BUILDING PLAN CHECK
00-00-8
★ APPROVED ★

ROOF TRUSS LAYOUT
24" o.c. Spacing

170810
Jones Addition
1597 Rose Avenue
Santa Rosa, CA

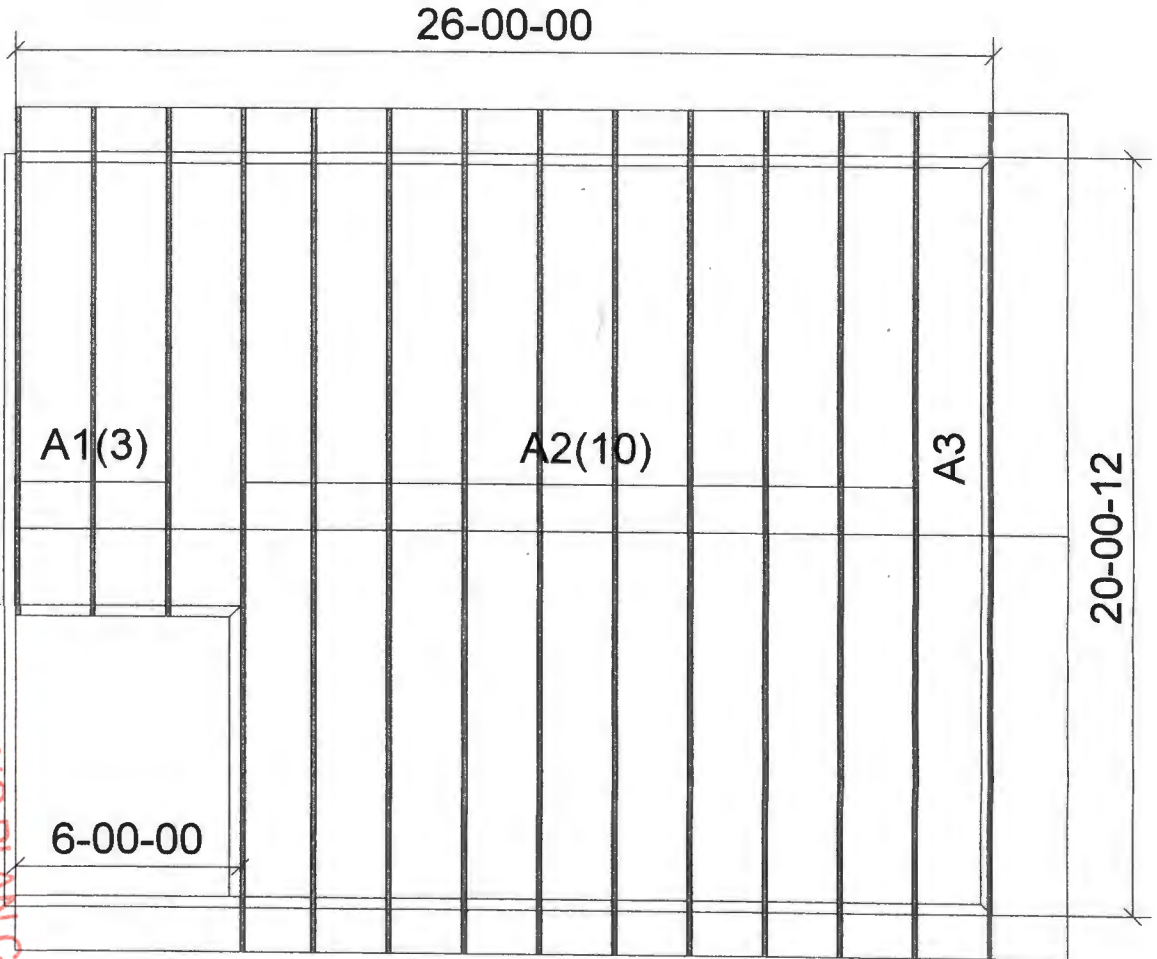
**Verify all Existing Condition
needed to match trusses to
Heel, Pitch, Overhang, & etc.**

Heel ?
